3.18 Certificate of Appropriateness – Historic District (HD)

ATTACHMENT 1

Sec. 5.15.5.A. Neighborhood Core Historic District, Building Type Requirements, Front Build-to Zone

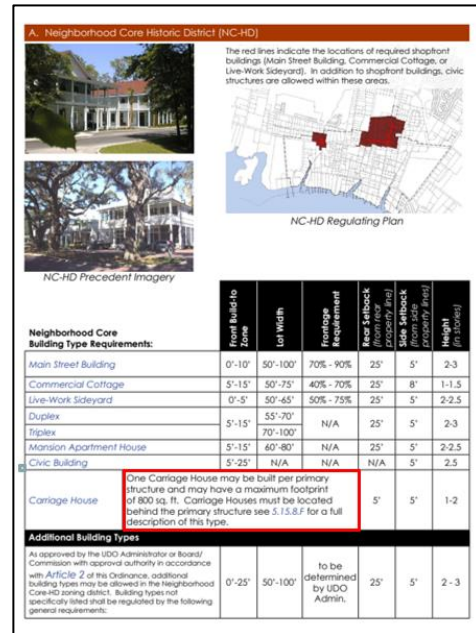
Proposed Changes: The increase in the minimum front build-to zone in the NC-HD and NCE-HD zoning districts increases the area between the buildings and the right-of-way by 5 feet, which does not include porches or stoops. At present, the front build-to, which typically has a 6-10 foot front porch area, extends beyond the front build-to. Since the minimum porch depth is 6 feet, a 5-foot build-to line is not possible should a front porch be proposed. The increase allows more flexibility to set the structure back farther on the lot and ensures there is at least a small amount of space at the front of the lot for the required street trees, foundation plantings, and will help to save large trees at the front of lots.

Neighborhood Core Building Type Requirements	Front Build-to Zone
Main Street Building	0' – 10' <u>10' – 20'</u>
Commercial Cottage	5' – 15' <u>10' – 15'</u>
Live-Work Sideyard	0' – 5' <u>10' – 15'</u>
Duplex	5' – 15' <u>10' – 15'</u>
Triplex	5' – 15' <u>10' – 15'</u>
Mansion Apartment House	5' – 15' <u>10' – 25'</u>
Civic Building	5' – 25' <u>10' – 25'</u>
Additional Building Type	0' – 25' <u>10' – 25'</u>

Sec. 5.15.6.E.4. Cupolas/Small Footprint Towers

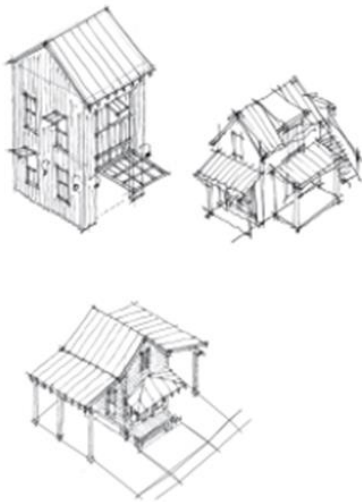
Proposed Changes: Formatting and providing clarity regarding maximum height.

- ~~Plan Area Footprint: =20' x 20' Maximum Footprint~~
- ~~Height: Cupolas and towers may extend a maximum of 15 feet above the Zoning District height limit. roof ridge but shall not be taller than 50 feet above the adjacent grade level.~~
